CROW BUTTE RESOURCES, INC.

Re: Docket No. 40-8943
License No. SUA-1534
Annual Report of Changes, Tests, or Experiments

2004 SERP Evaluation Index

SERP #04-01

Figure 5.1-1: Crow Butte Resources Organizational Chart

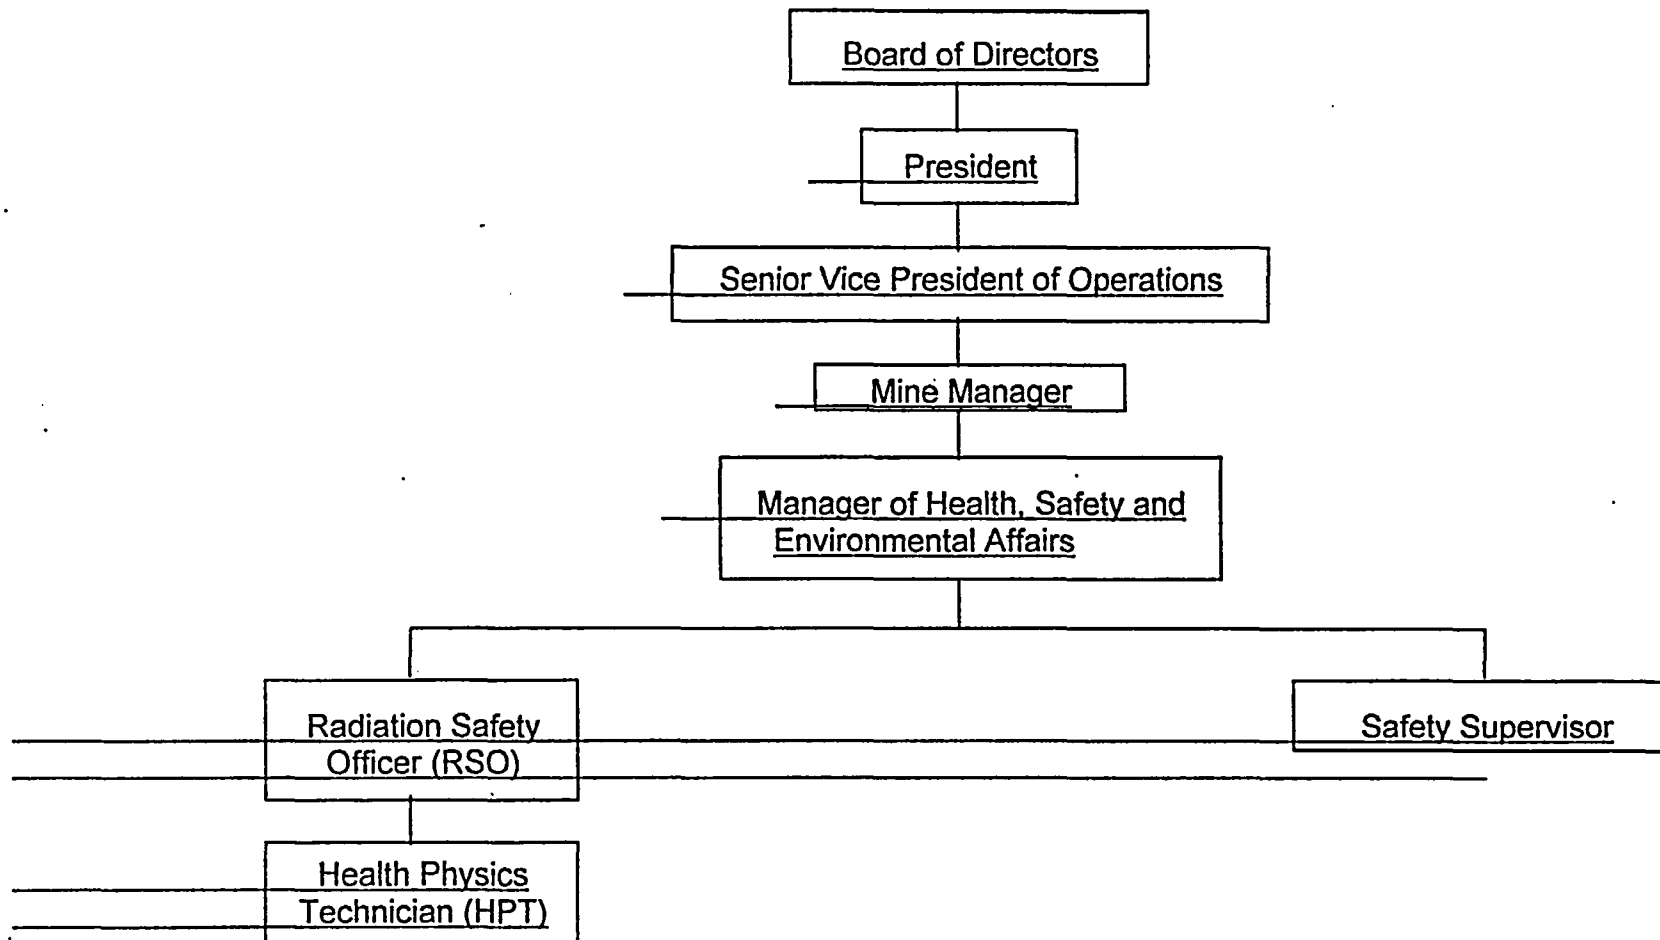
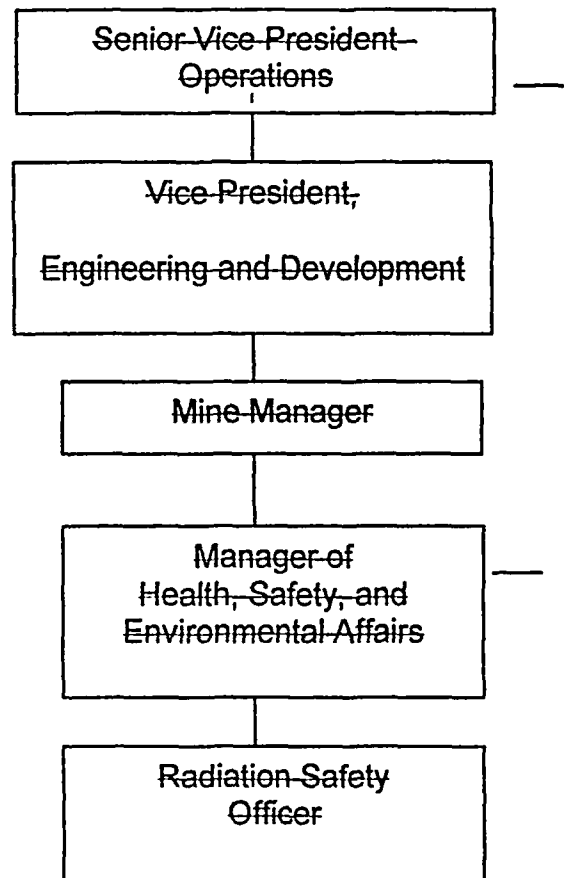
2. An organizational change has been made that indirectly affects the reporting responsibilities of the radiation safety staff. Specifically, the reporting for the Mine Manager has been changed as shown in the revised Figure 5.1-1 from the approved application. The Mine Manager now reports directly to the Senior Vice President – Operations. Since the RSO reports to the Manager of Health, Safety, and Environmental Affairs who in turn reports to the Mine Manager, a change in the reporting for the Mine Manager will indirectly affect the radiation safety staff reporting.

Figure 5.1-1 is a partial organization chart for CBR with respect to the operation of the Crow Butte Uranium Project and associated operations and represents the management levels that play a key part in the EMS Program. The personnel identified are responsible for the development, review, approval, implementation, and adherence to operating procedures, radiation safety programs, environmental and groundwater monitoring programs as well as routine and non-routine maintenance activities. These individuals may also serve a functional part of the Safety and Environmental Review Panel (SERP) described under Section 5.3.3.

The Mine Manager is responsible for all uranium production activity at the project site. The Mine Manager is also responsible for implementing any industrial and radiation safety and environmental protection programs associated with operations. The Mine Manager is authorized to immediately implement any action to correct or prevent hazards. The Mine Manager has the responsibility and the authority to suspend, postpone or modify, immediately if necessary, any activity that is determined to be a threat to employees, public health, the environment, or potentially a violation of state or federal regulations. The Mine Manager cannot unilaterally override a decision for suspension, postponement or modification if that decision is made by the Senior Vice President of Operations and/or the Manager of Health, Safety and Environmental Affairs. The Mine Manager reports directly to the Senior Vice President of Operations.

Figure 5.1-1: Crow Butte Resources Organizational Chart

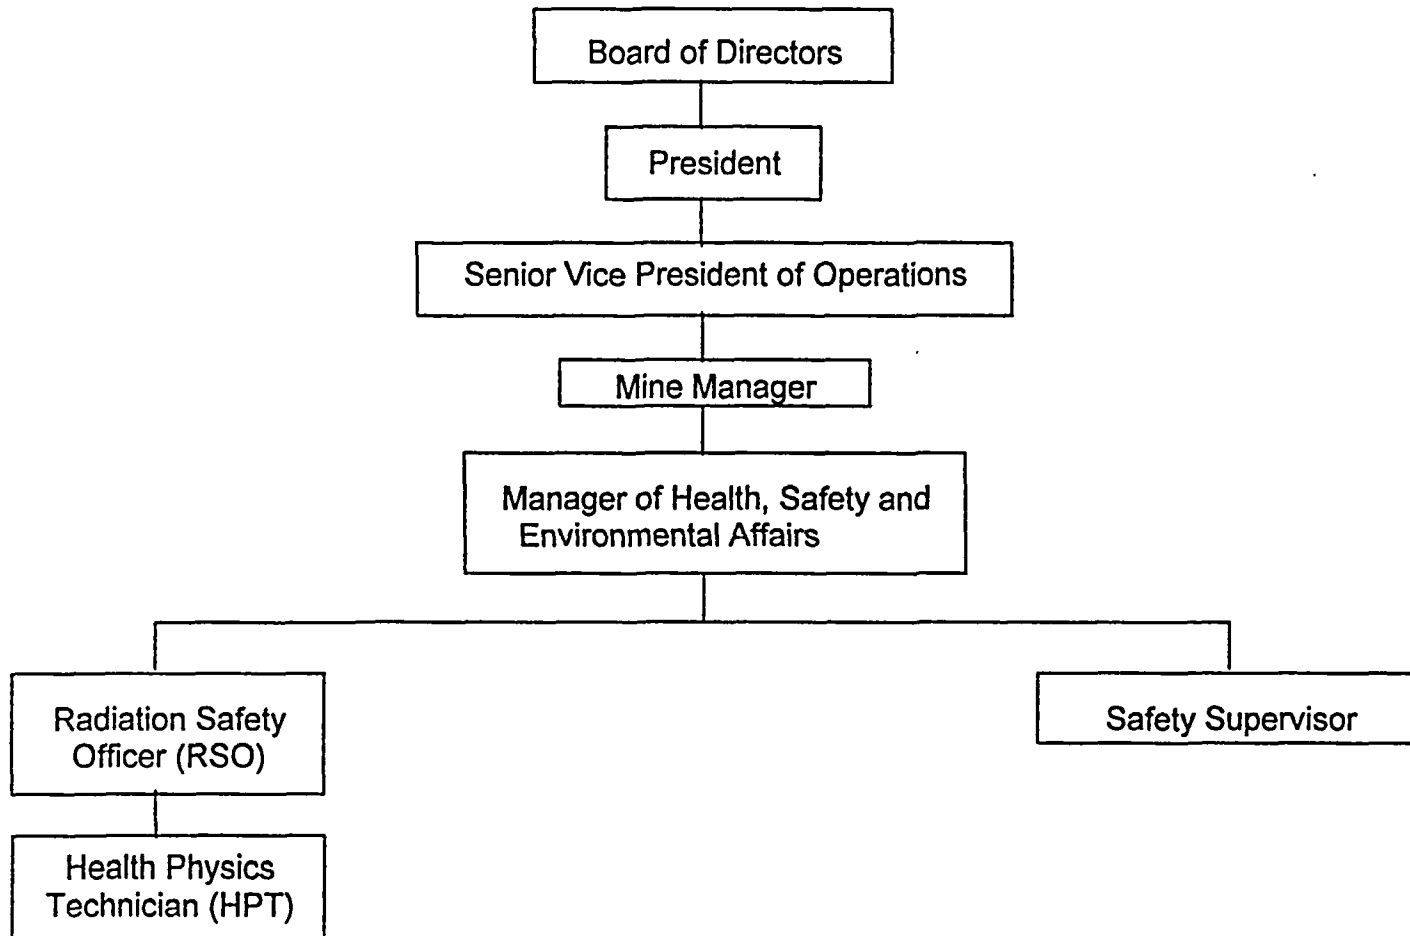
Figure 5.1-1 is a partial organization chart for CBR with respect to the operation of the Crow Butte Uranium Project and associated operations and represents the management levels that play a key part in the EMS Program. The personnel identified are responsible for the development, review, approval, implementation, and adherence to operating procedures, radiation safety programs, environmental and groundwater monitoring programs as well as routine and non-routine maintenance activities. These individuals may also serve a functional part of the Safety and Environmental Review Panel (SERP) described under Section 5.3.3.
